REGIONAL REVIEW NOTIFICATION

ARC REVIEW CODE: R1904221

Name of Proposal: Gardner 42 Expansion (DRI 2939)

GARDNER 42 EXPANSION DRI
City of Locust Grove
Natural Resources Group Review Comments

DRI SITE PLAN

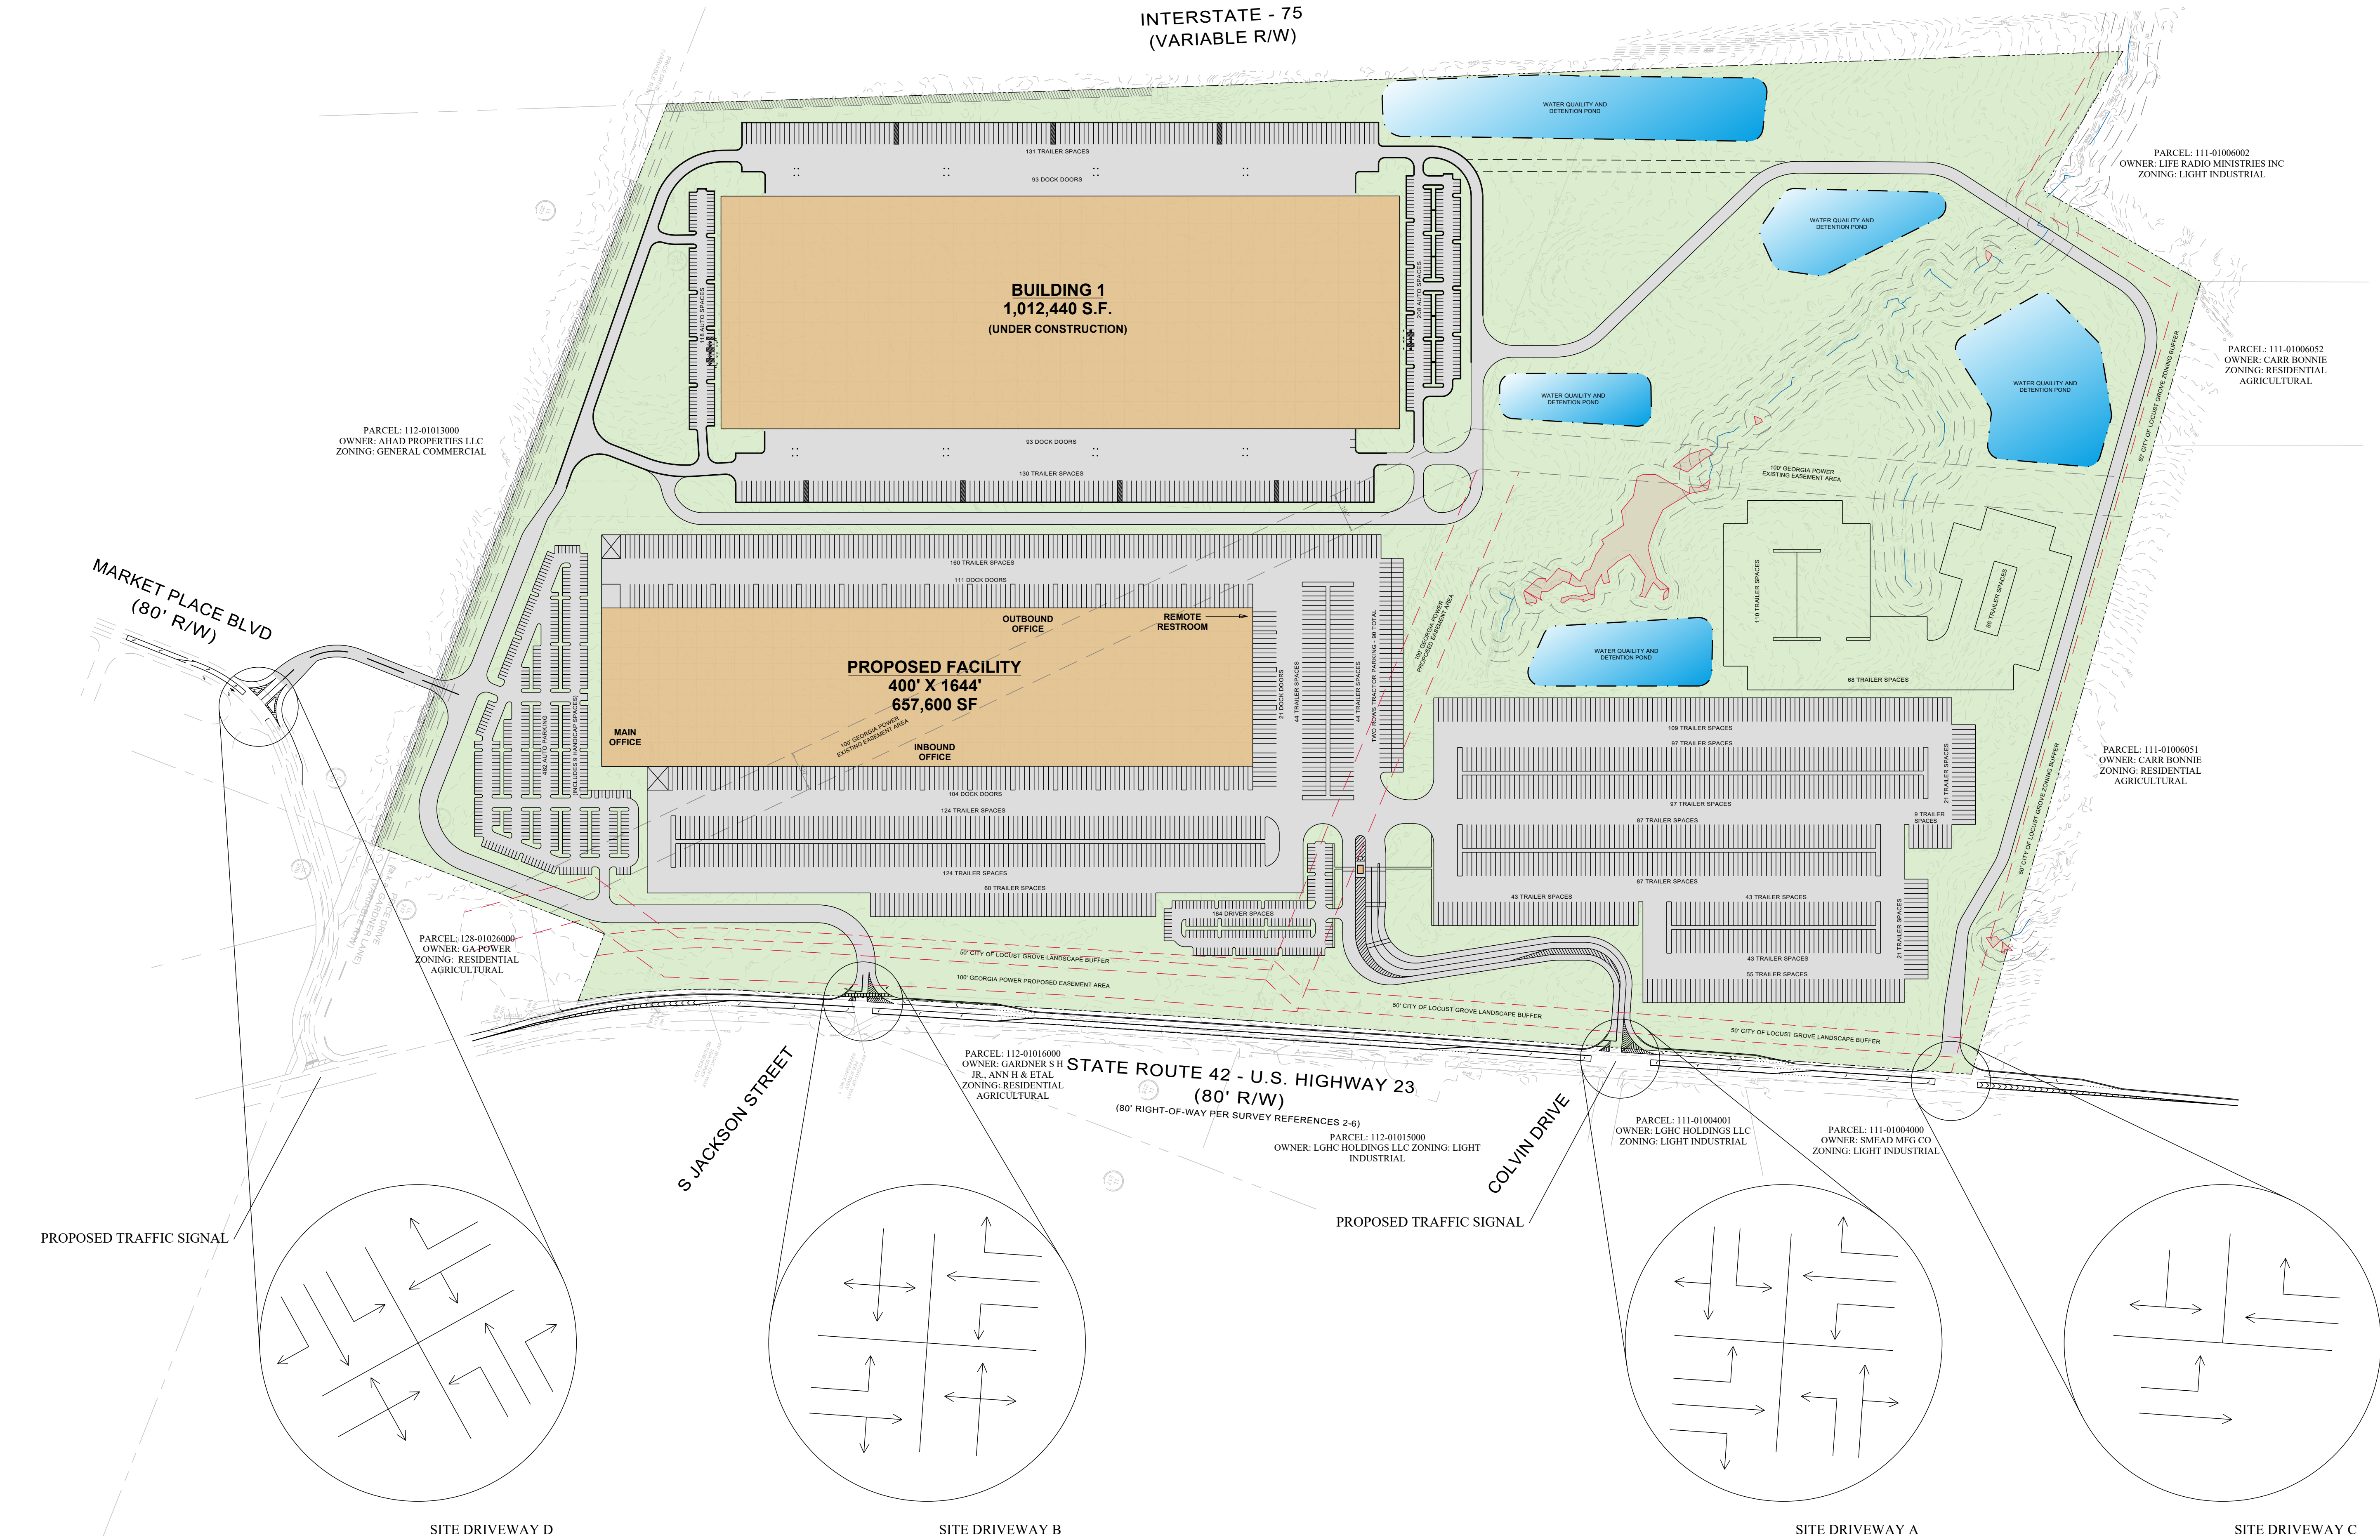
In addition, the development team should ensure that project driveways and associated improvements (e.g., turn lanes, deceleration lanes, etc.) are implemented in coordination with GDOT and the City of Locust Grove to safely and efficiently accommodate the DRI's projected traffic, especially trucks. This is of particular importance relative

to Site Driveways A, B and C, all of which are on SR 42 and some of which (Driveways A and B) intersect with public streets (Colvin Dr. and S. Jackson St., respectively). Finally, the development should not preclude the potential future provision of interparcel access to the undeveloped parcel to the north, if warranted by future conditions.

No stubouts are proposed. Market Place Blvd, a local road, provides access to adjacent parcels, Vehicles will have to access adjacent parcel by SR 42.

The development doesn't propose internal or external sidewalk facilities.

All four driveways proposed allow for shared access and maneuvering of vehicle and freight traffic .

The development should consider constructing pedestrian facilities such as sidewalks on site frontage along SR 42.
